Resurvey on Kilmain - Pre-Preliminary Plan No. 720150110

Staff Report Date: 4/7/17

Resurvey on Kilmain - Pre-Preliminary Plan No. 720150110: Request for one, 14.51-acre lot; located on Club Hollow Road approximately 1,500 feet west of Edwards Ferry road. Agricultural Reserve Zone, *Agricultural and Rural Open Space (AROS) Master Plan.*

Staff Recommendation: Approval of the pre-preliminary plan prior to submittal of a minor subdivision record plat pursuant to Section 50-35A(a)(8) with conditions.

21707 CLUB HOLLOW ROAD
 PROP. LOT 1 (N/F PARCEL 510)
 RESURVEY ON KILMAIN
 FIRE DEPARTMENT ACCESS &
 CISTERN EASEMENT PLAN
 MNCPPC NO. 72015010

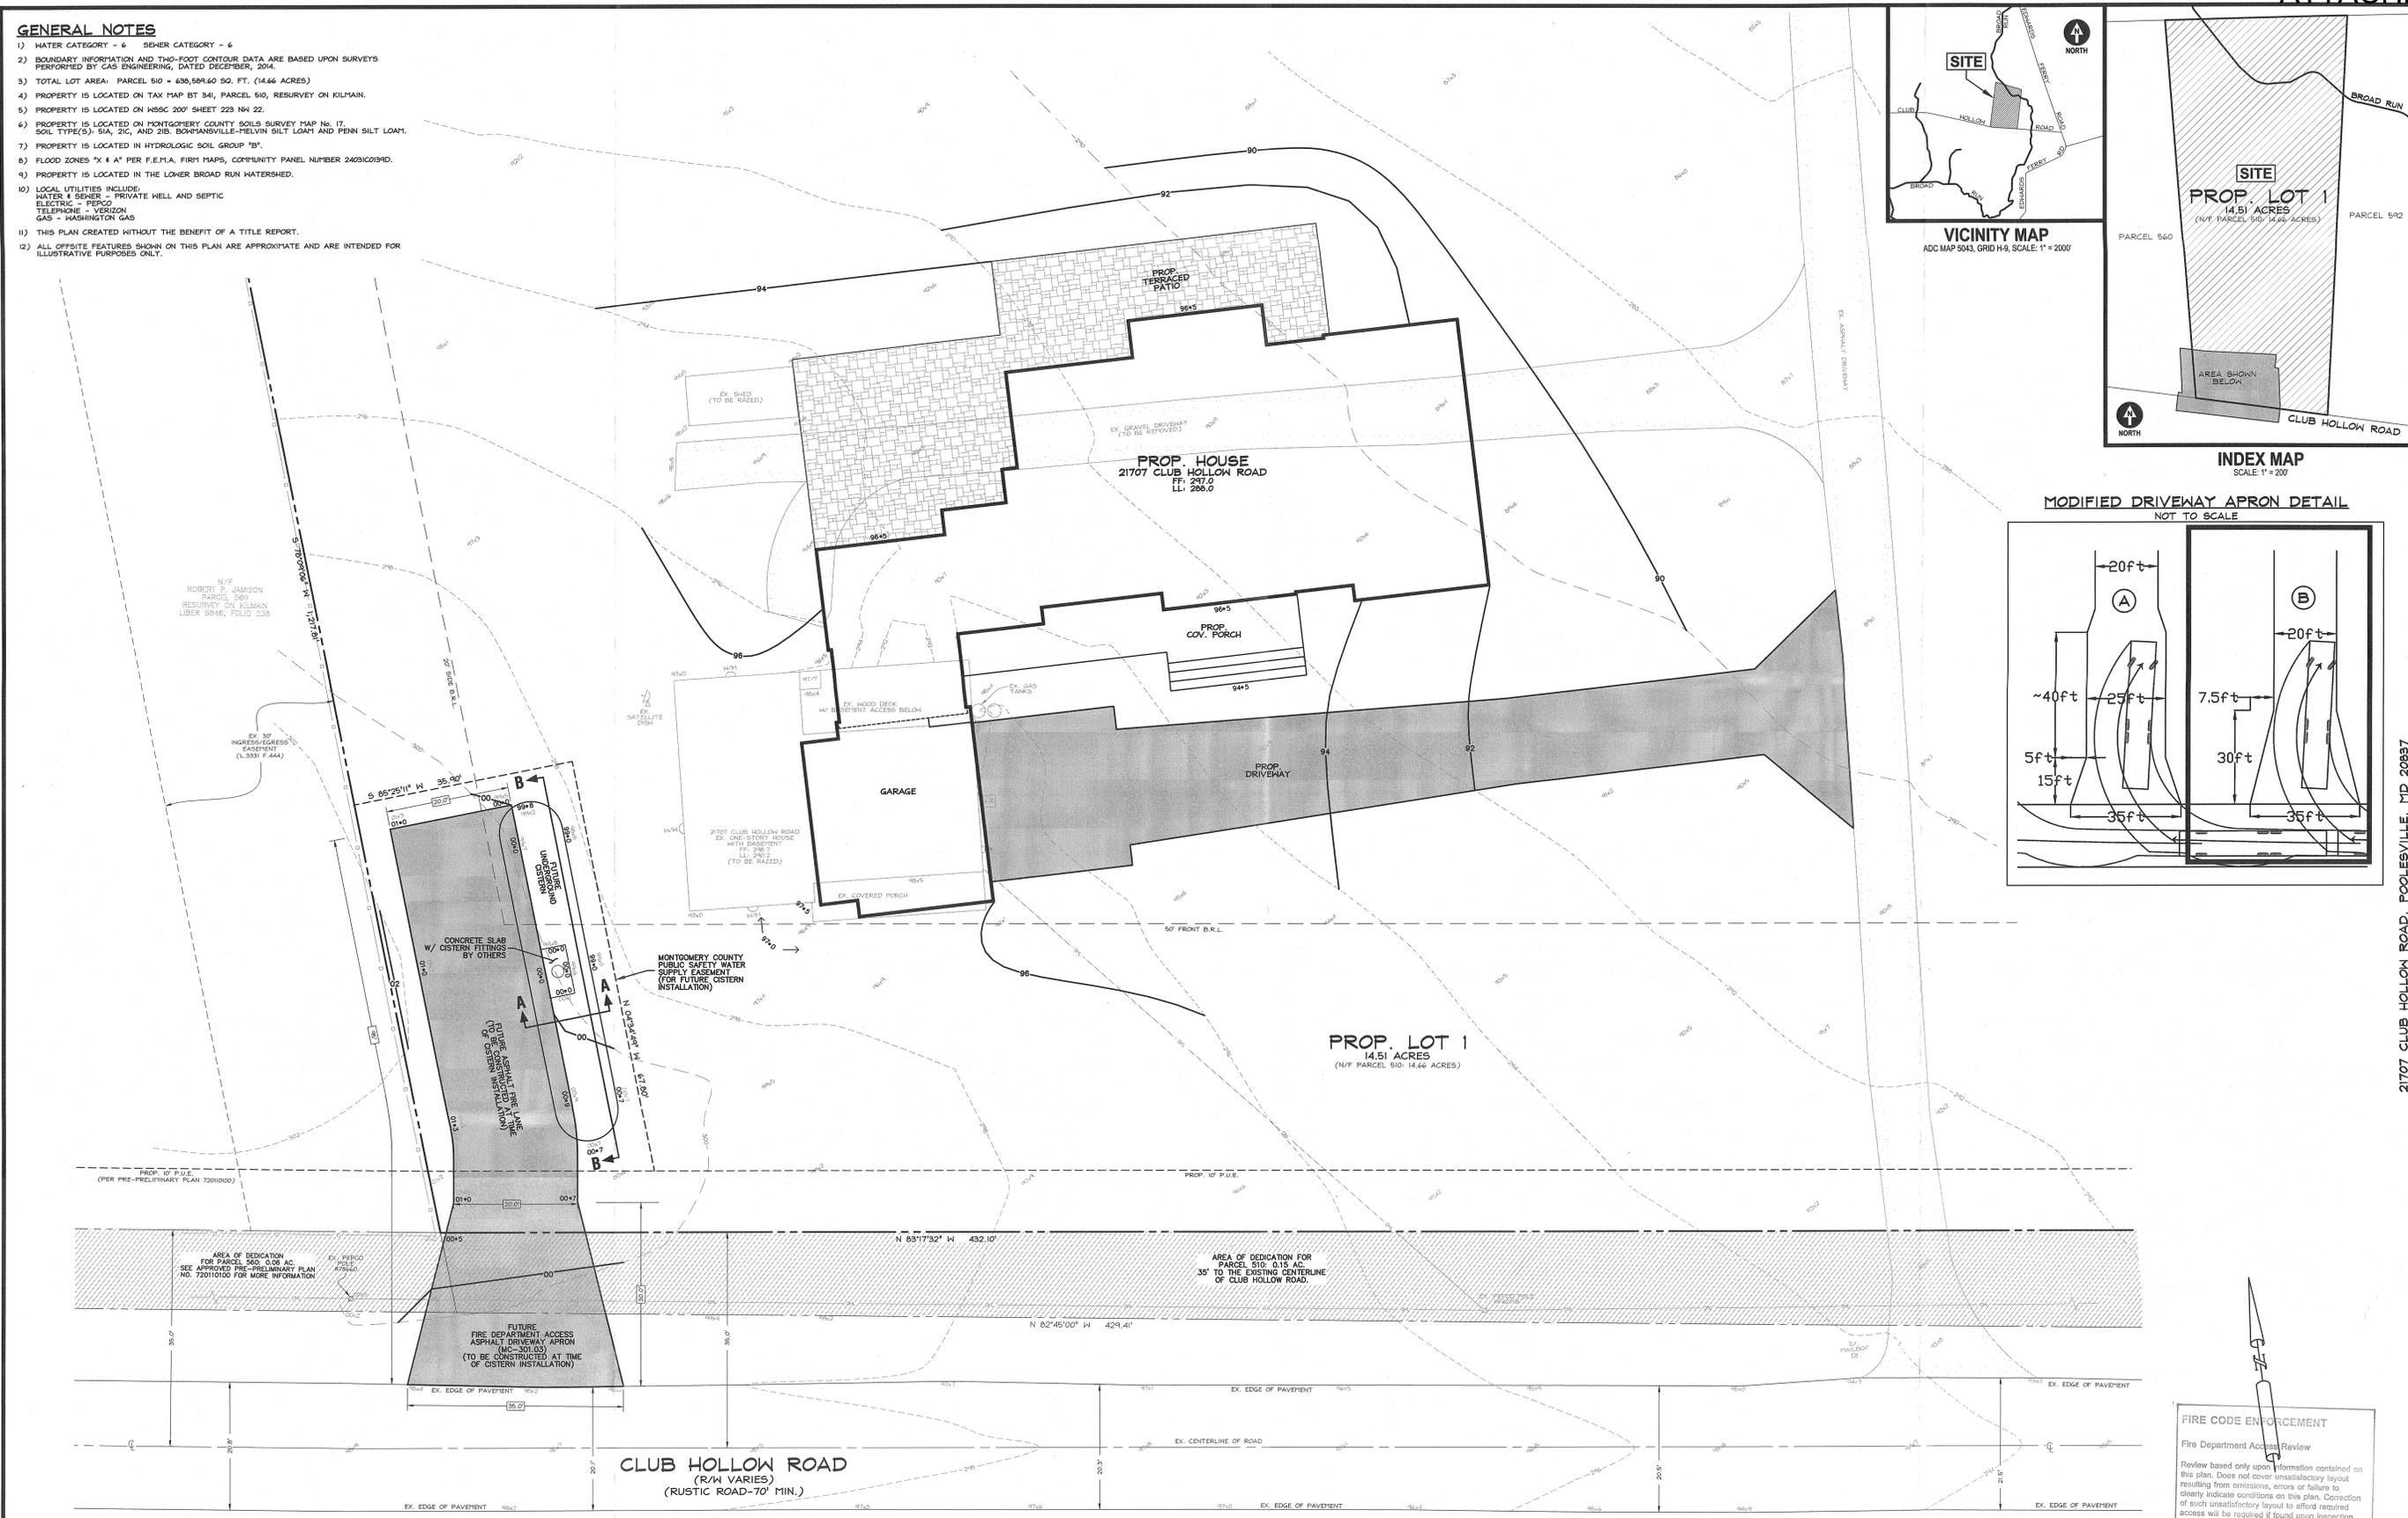
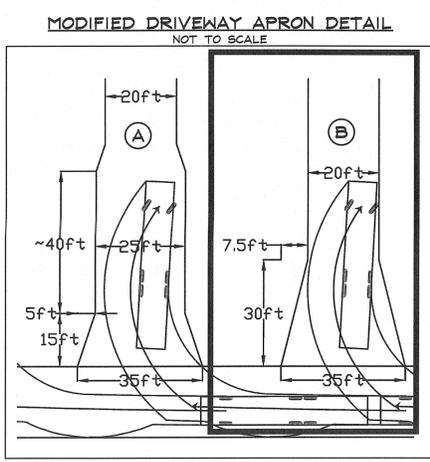
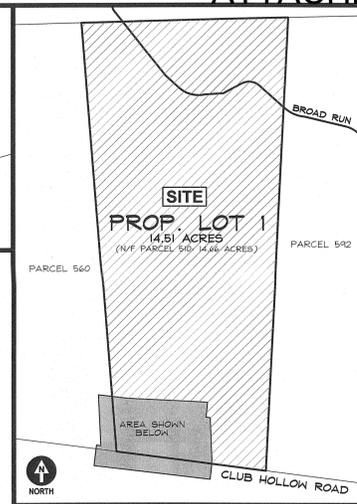
Thank you for presenting the joint fire cistern easement alternative on Club Hollow Road, a rustic road, to our committee on November 29, 2016.

There are currently two fire cistern easement areas proposed on two adjacent properties, the Bassett and Jamison properties, on this rustic road. We understand that neither property owner is being asked to install a cistern or access driveway; the easements would allow future installation by others. The Jamison easement is parallel to the road, and would involve widening the rustic road by approximately 12 feet. The Bassett easement is perpendicular to the rustic road, and involves a 32-foot wide paved driveway and fire cistern access area, close to and in clear view of the rustic road. We consider both proposals to negatively impact the character of the rustic road.

To reduce the negative impacts, a single easement is proposed at the southwestern corner of the Bassett Property. The alternative you have provided us (dated 12/13/2016) shows an easement perpendicular to the road, adjacent to the common property boundary that will accommodate the future 20-foot driveway and fire cistern. As proposed, there will be three above-ground structures that may be visible from the rustic road: a dry hydrant, a concrete slab, and a circular lid that cover an access point to the cistern vault. The proposed structures are to be approximately 41 feet outside of the proposed right-of-way. A 20-foot driveway will be located within the right-of-way to provide access to the proposed cistern.

We recommend approval of this proposed fire access easement, contingent upon the removal of the other two cistern easements proposed on the Bassett and Jamison properties. At the time of permitting, if the following elements cannot be accommodated, we would like to review the final plans:

- The access driveway should be constructed at the time of installation of the cistern.
- MCDPS staff reviewing this fire access easement has indicated that the driveway can be constructed with an appropriate gravel mix; gravel is preferred to asphalt.
- The driveway apron width should match the existing 26-foot wide apron on the fire cistern installation on Stoney Creek Road, a rustic road.

- Provide screening for the above-ground structures using native plants arranged in a naturalistic design.

PLAN APPROVED

1. Review based only upon information contained on the plan submitted **20-Dec-16** .Review and approval does not cover unsatisfactory installation resulting from errors, omissions, or failure to clearly indicate conditions on this plan.
2. Correction of unsatisfactory installation will be required upon inspection and service of notice of violation to a party responsible for the property.

***** Modified easement location *****
